BLOCK 834 LOT 9 QUALIFICATION CODE C16-34 C16-34-1 ADDRESS (SITE) 1657 FORGE POND Rd PERMIT NO. 02-0191

CONSTRUCTION PERMIT APPLICATION

NEW SINGLE-FAMILY HOME
4 BR 2½ BATH 2 CAR GARAGE BASEMENT

Please be advised of the following changes to the plans which are acceptable:

WINDOW/DOOR DETAIL

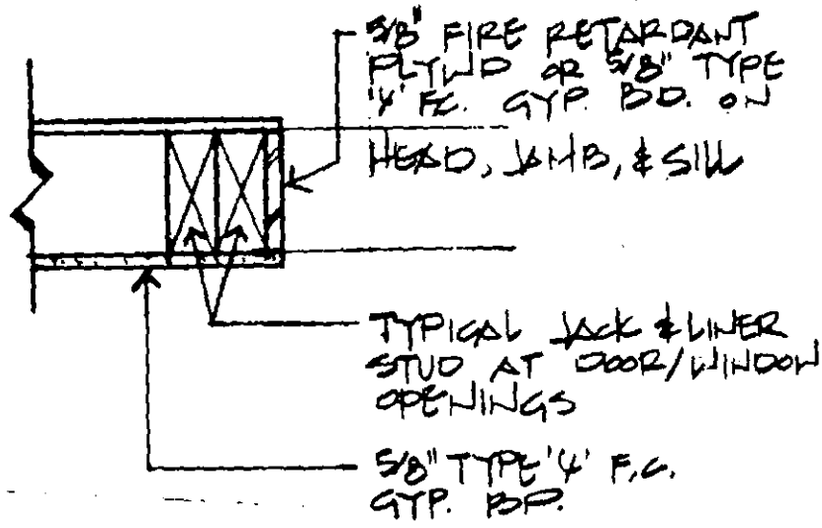
1. Construction Classification has been changed from Type 5B to Type 5A
2. All gypsum board to be utilized in the residence shall be 5/8" type 'x' fire code gypsum board.
3. All framing of windows and doors in the exterior and interior bearing walls, shall be wrapped with 5/8" type 'x' f.c. gypsum board or 5/8" fire retardant plywood. A detail is enclosed for your use.

TYPICAL AT ALL WINDOW LOCATIONS & INTERIOR DOORS IN LOAD BEARING WALLS

WINDOW/DOOR DETAIL

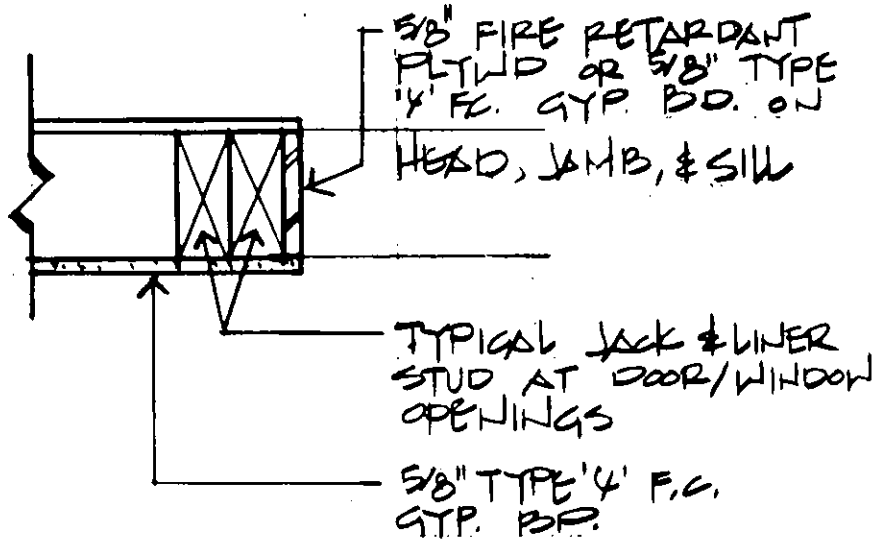
1. Construction Classification has been changed from Type 5B to Type 5A
2. All gypsum board to be utilized in the residence shall be 5/8" type 'x' fire code gypsum board.
3. All framing of windows and doors in the exterior and interior bearing walls, shall be wrapped with 5/8" type 'x' f.c. gypsum board or 5/8" fire retardant plywood. A detail is enclosed for your use.

TYPICAL AT ALL WINDOW LOCATIONS & INTERIOR DOORS IN LOAD BEARING WALLS

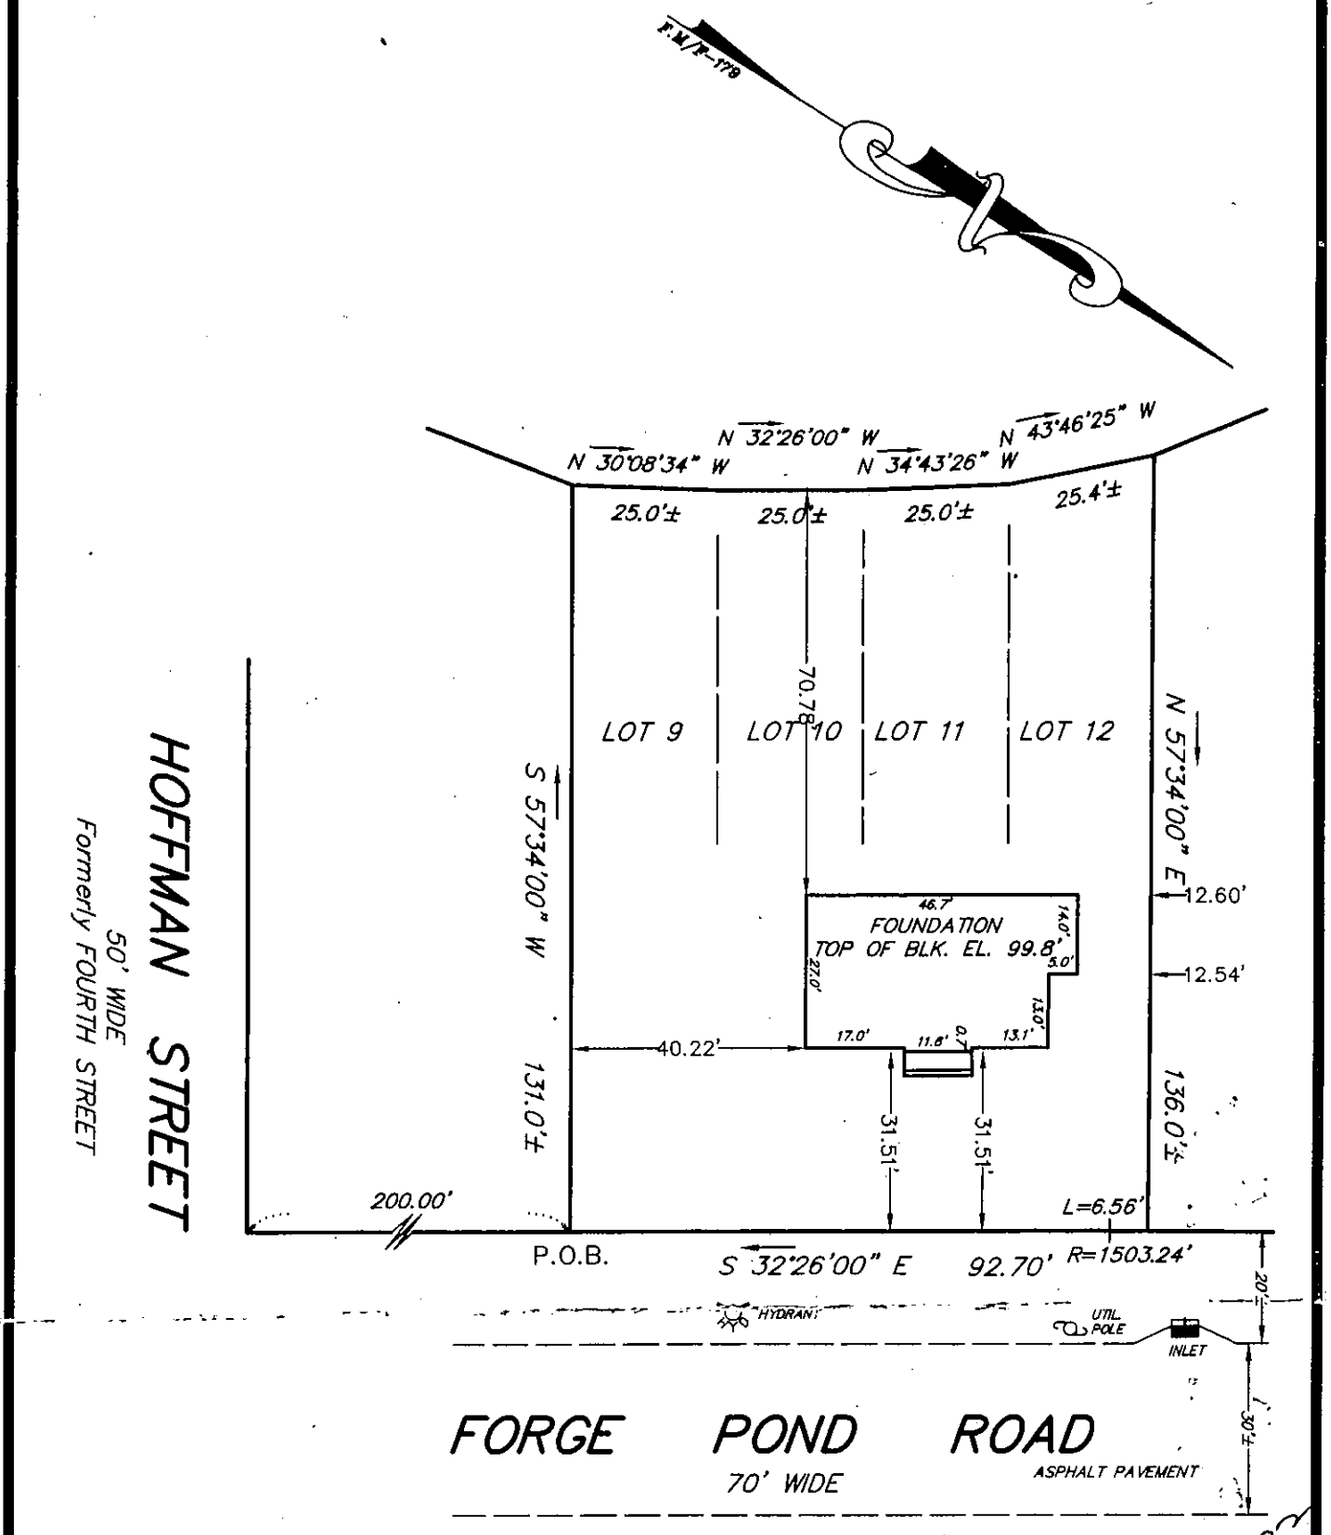
REVISED 2/14/02 - FOUNDATION LOCATION

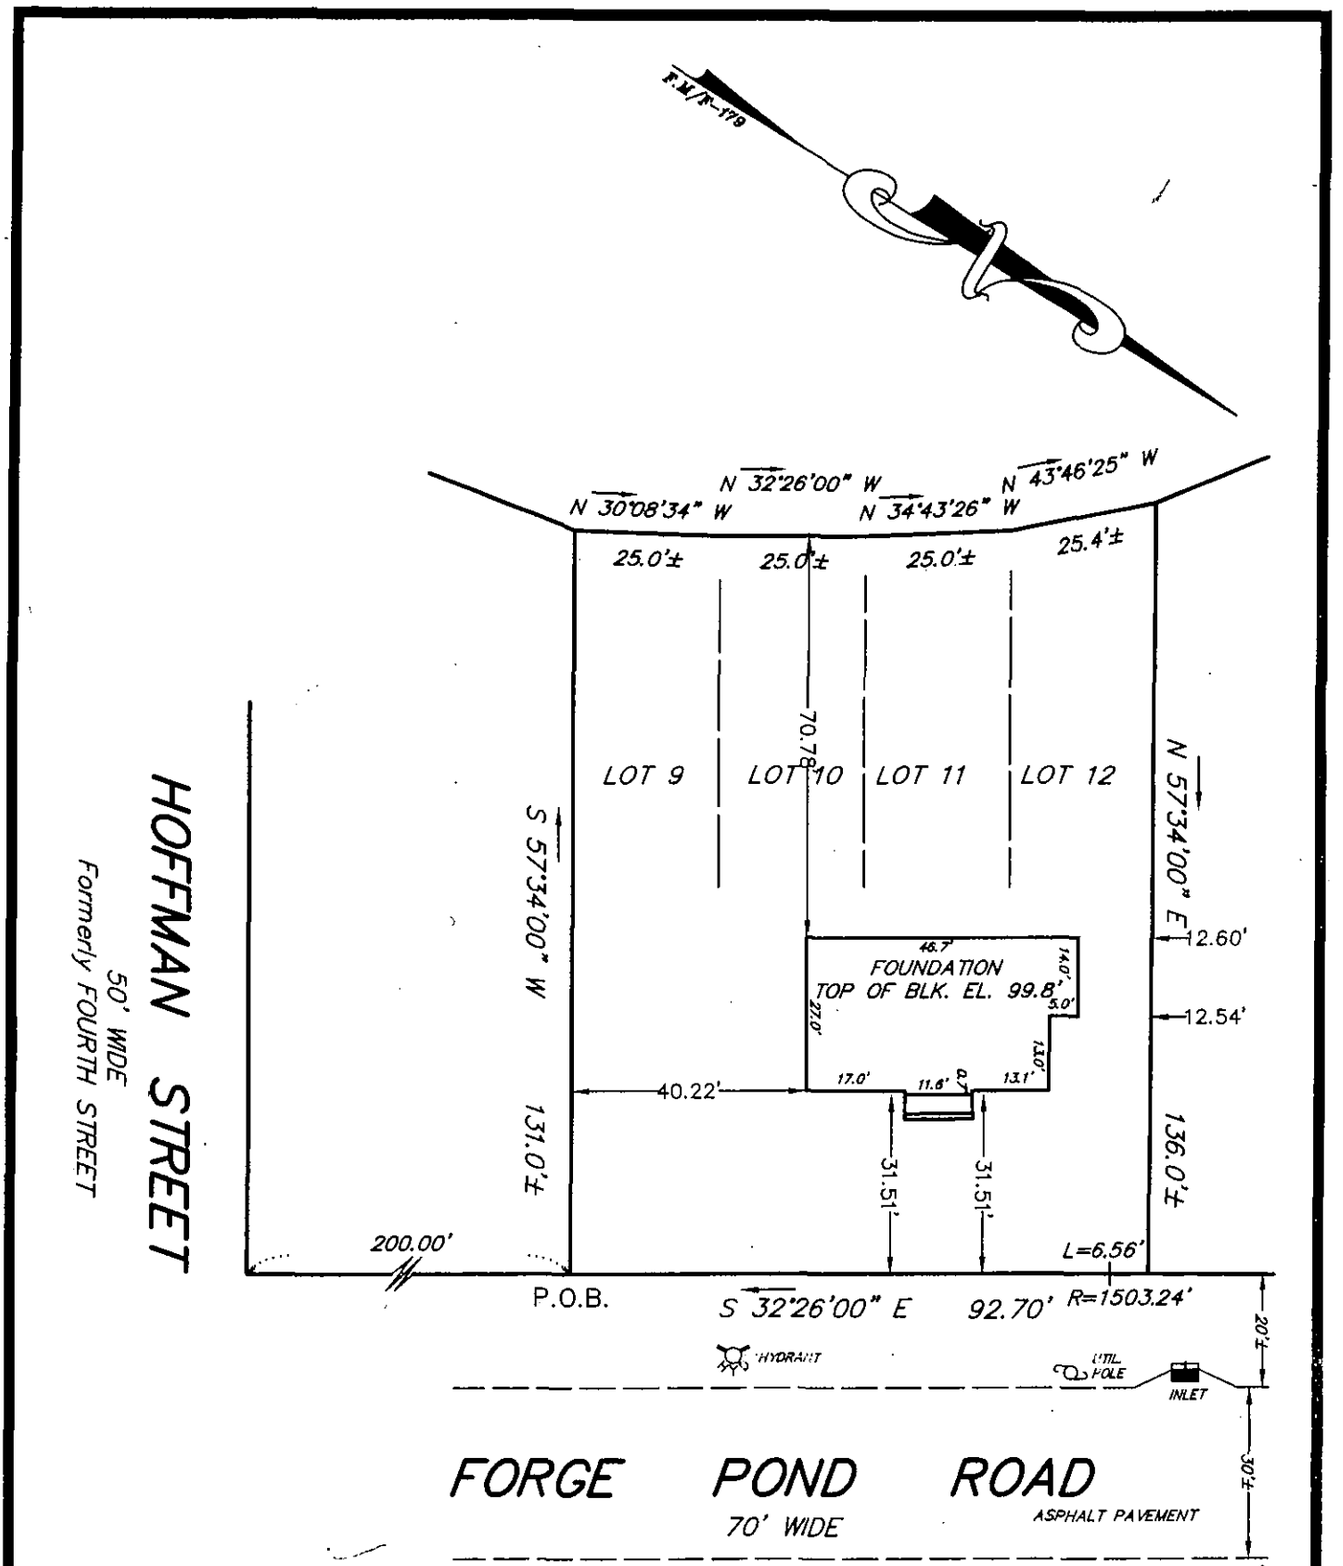
REVISED 2/14/02 - FOUNDATION LOCATION
